**SHEARON HARRIS NUCLEAR POWER PLANT, UNITS 2 AND 3
DOCKET NOS. 52-022 AND 52-023
RESPONSE TO REQUEST FOR ADDITIONAL INFORMATION FOR THE ENVIRONMENTAL
REVIEW – GIS DATA NEEDS**

NRC RAI NUMBER: 3.1-1

PGN RAI ID #: H-0661

Plant Layout and
Potentially Disturbed Area
Attachment RAI 3.1-1A

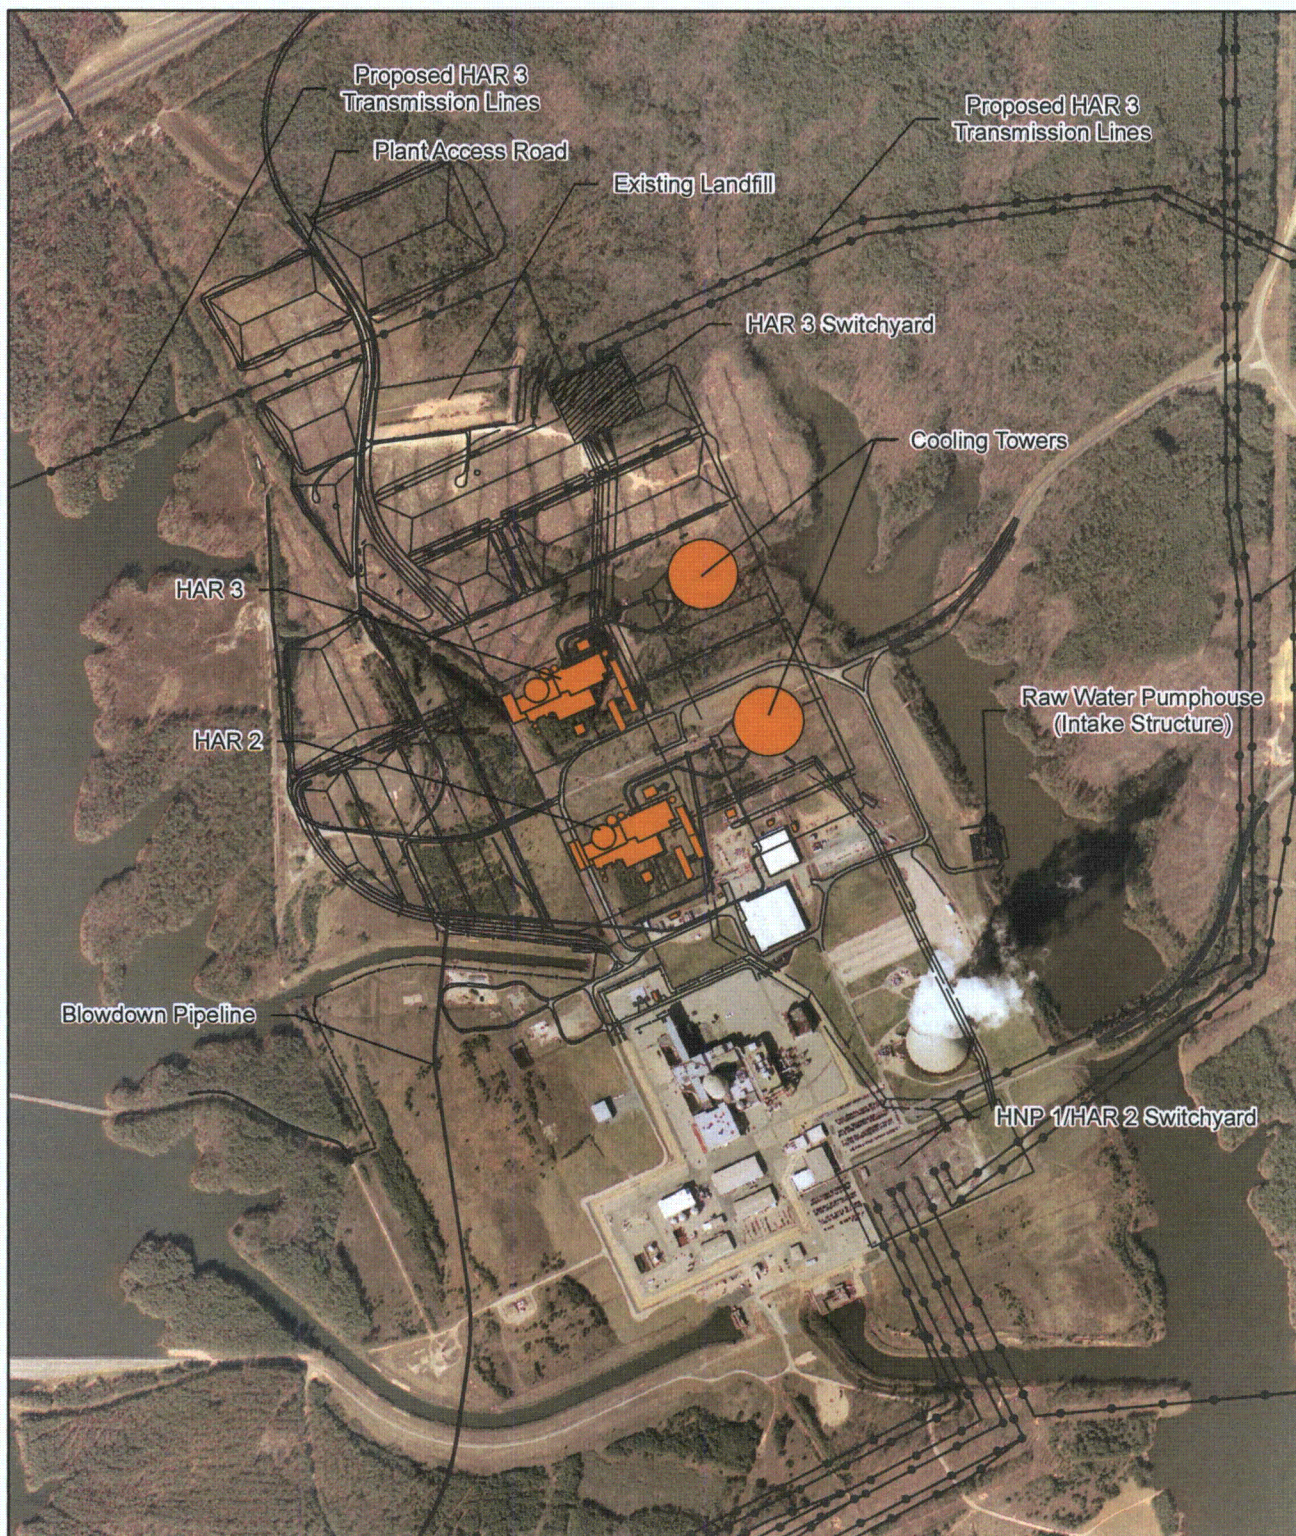
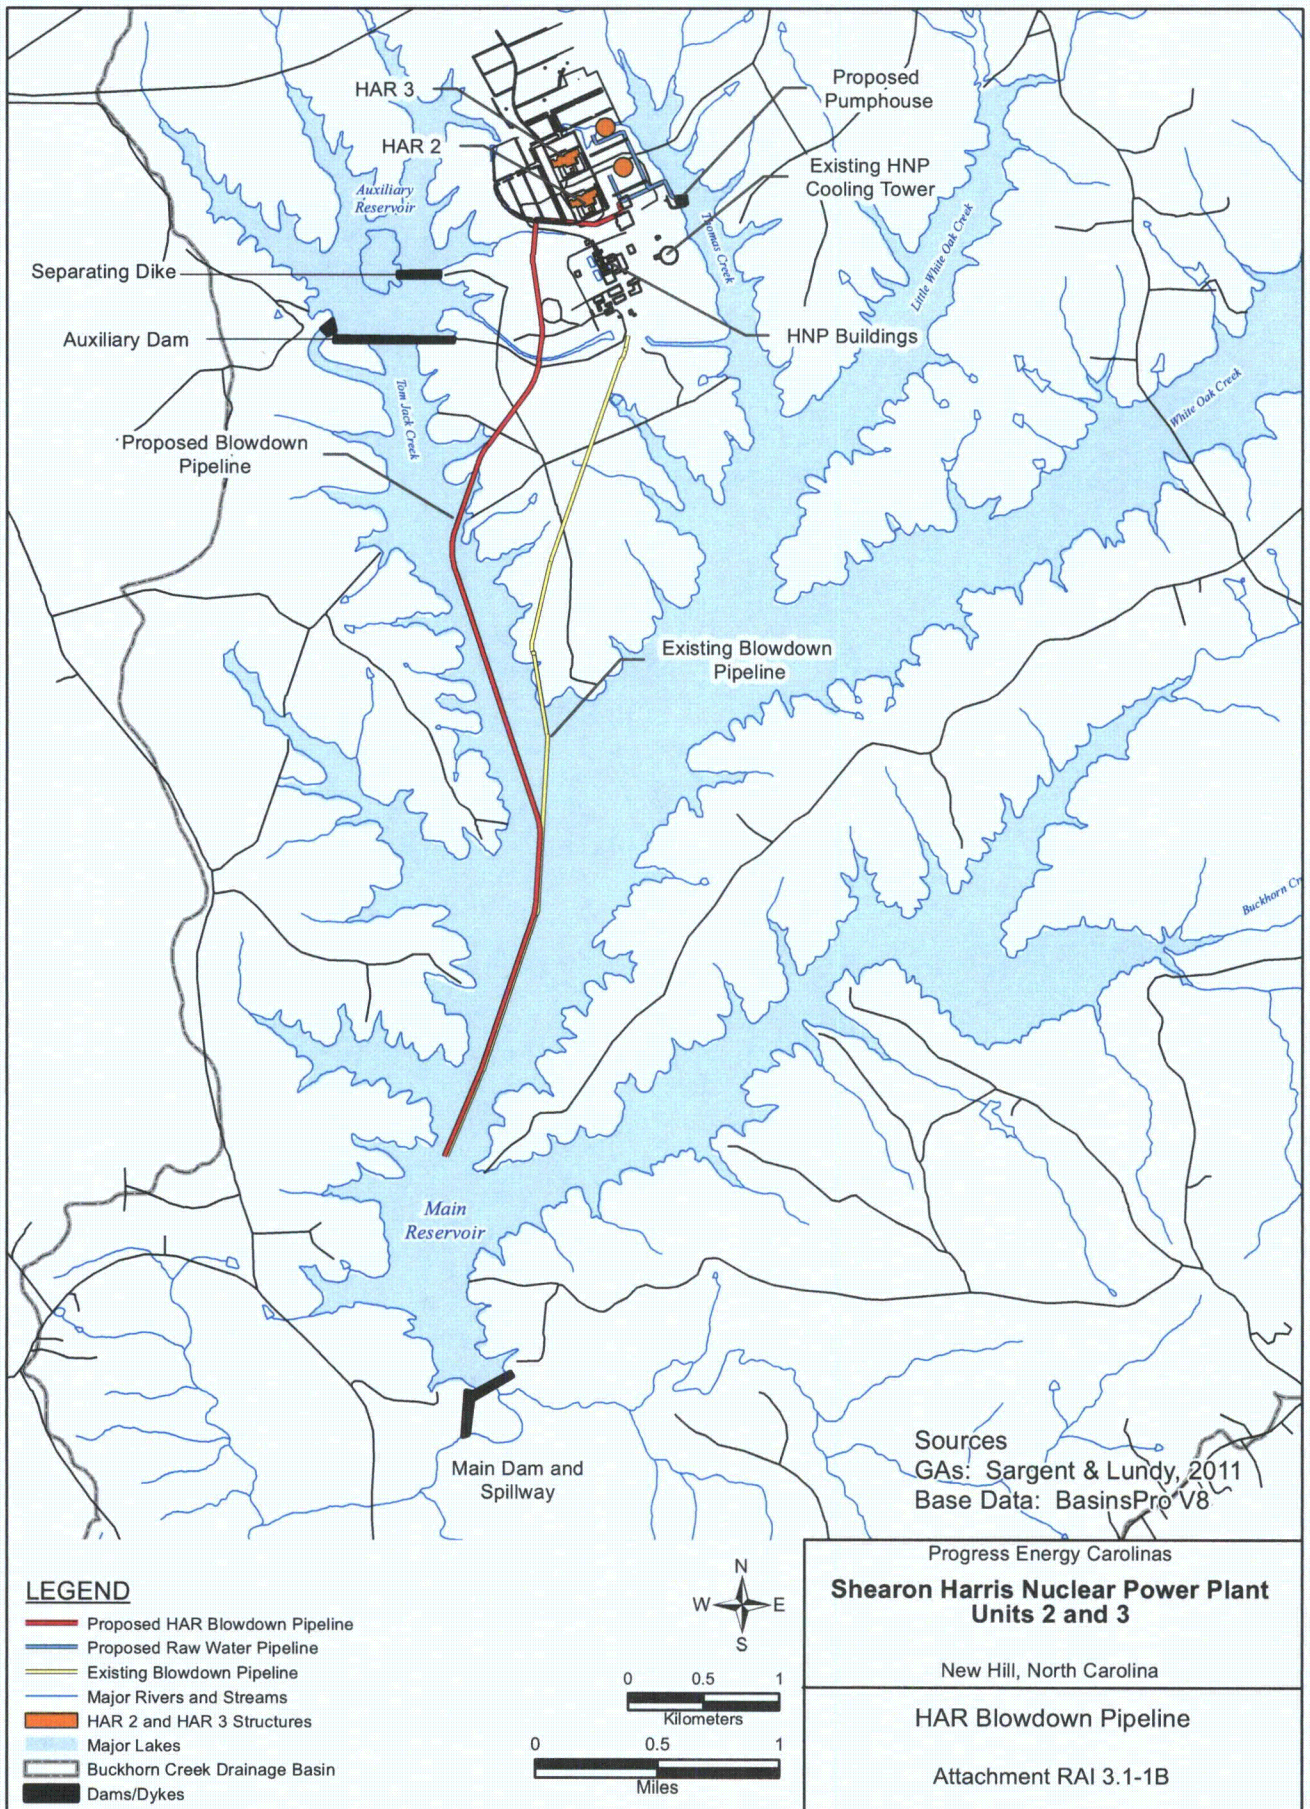
- HNP-1 (and HAR 2) 230-kV switchyard (ESRP 3.7; ER Fig 3.1-3 and/or Fig 4.0-2)
- HNP-1 blowdown piping and discharge pipeline (ER Fig 3.1-3)
- Any existing dredged material and other spoils storage areas

- HNP-1 (and HAR 2) 230-kV switchyard is shown in Attachment RAI 3.1-1A.
- HNP-1 blowdown piping and discharge pipeline is shown in Attachment RAI 3.1-1B as Existing Blowdown Pipeline.

- Disturbed areas for the entire project are shown in Attachment RAI 3.1-1A, Attachment RAI 3.1-1E, and Attachment RAI 3.1-1L. Modifications to roads and facilities related to raising Harris Reservoir are shown in Attachment RAI 3.1-1D and Attachment RAI 3.1-1I.

- Permanent parking areas will be located in the disturbed areas shown in Attachment RAI 3.1-1A. At this time the location of the permanent parking areas has not been identified. The areas being considered include the laydown areas west of the proposed HAR units, the area between HAR 2 and HAR 3, and an area north of HAR 3. Permanent parking will not be located underneath transmission lines.

- The disturbed areas shown on Attachment 3.1-1A include the raw water pumphouse, which is the intake structure.
- HAR 3 230-kV switchyard and transmission lines connecting it to the existing transmission system are shown in Attachment RAI 3.1-1A and Attachment RAI 3.1-1L.

ATTACHMENT RAI 3.1-1D

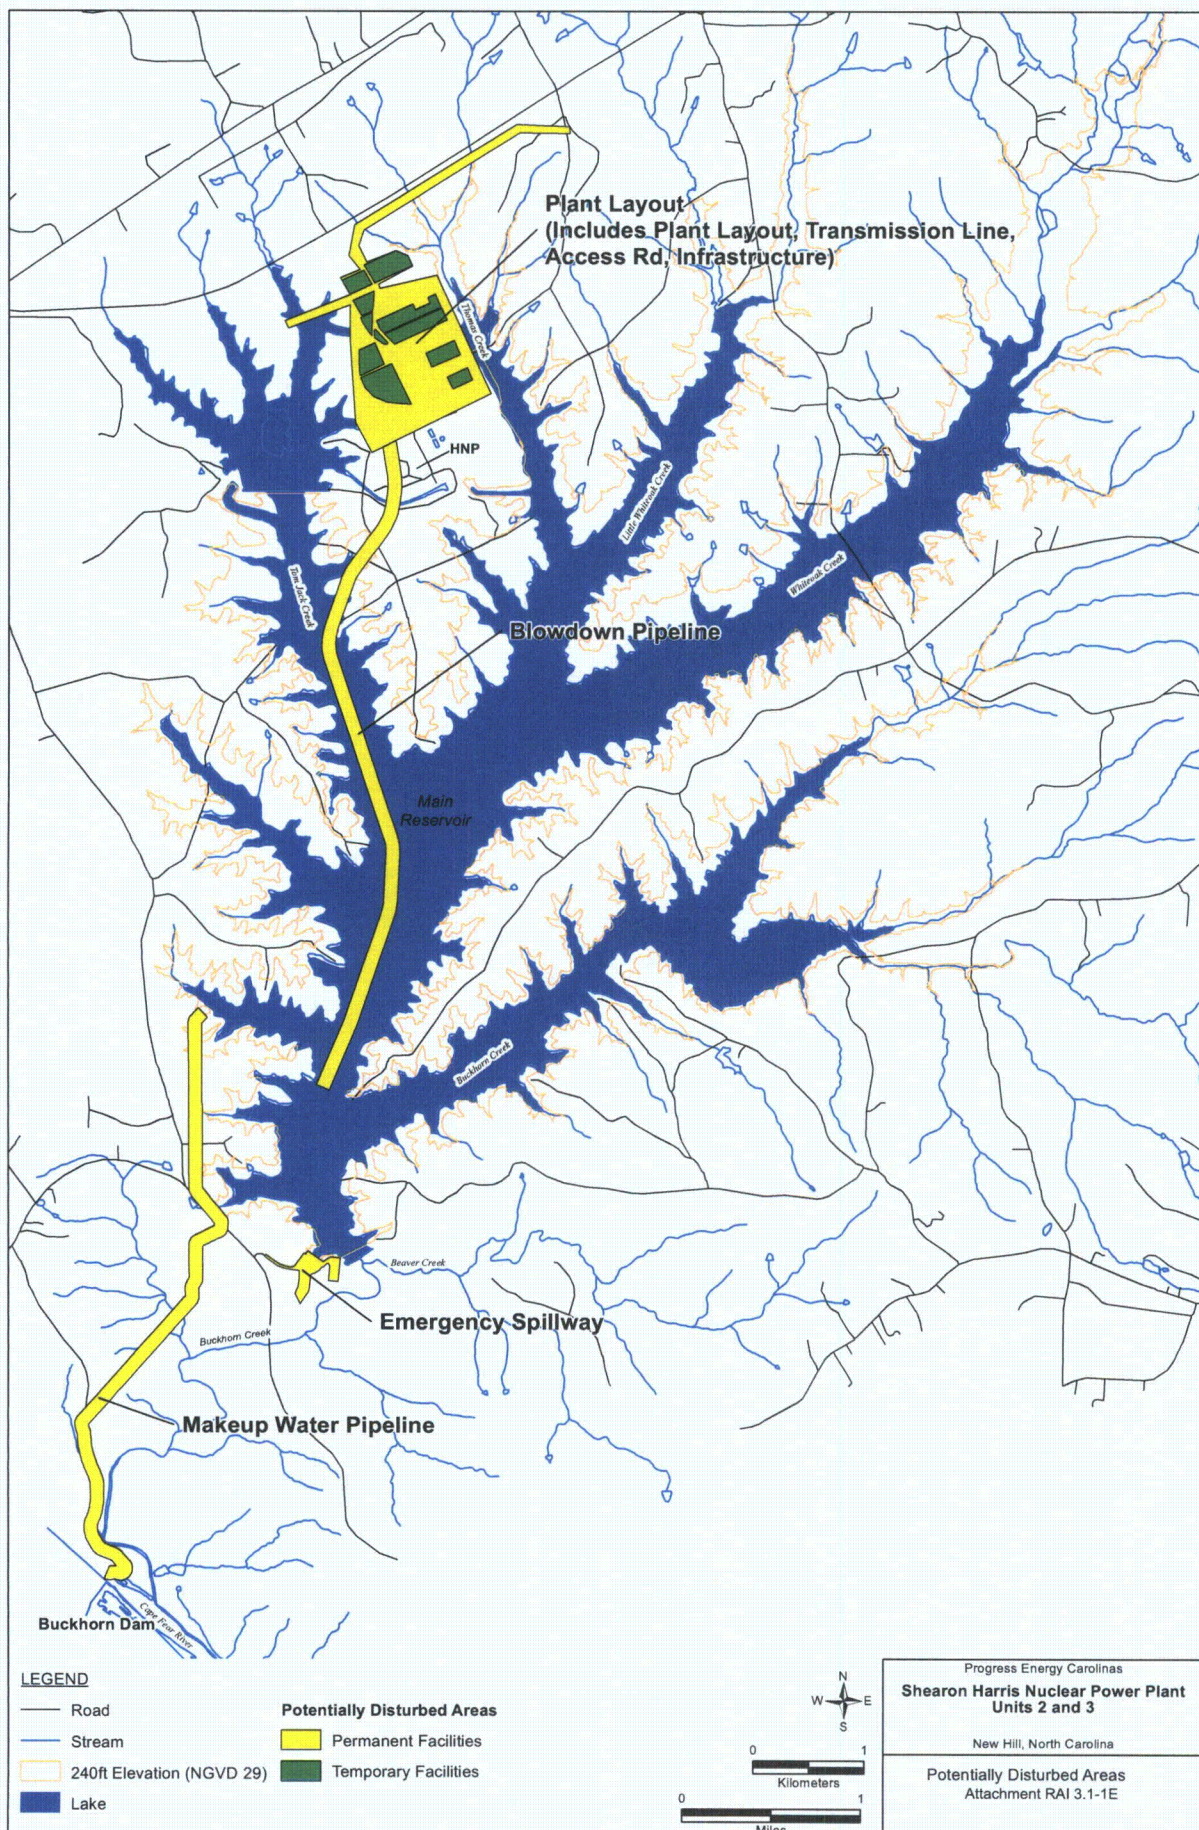
- Proposed new roads (e.g. new main access road (ER Fig 4.0-11), construction access road). These need to be differentiated from existing roads.
- Locations of proposed improvements to existing roads on site and immediate vicinity

- Proposed new roads are shown in Attachment RAI 3.1-1A, Attachment RAI 3.1-1C, Attachment 3.1-1D, and Attachment RAI 3.1-1I.
- Locations of proposed improvements to existing roads on the site and the immediate vicinity are shown in Attachment RAI 3.1-1D.
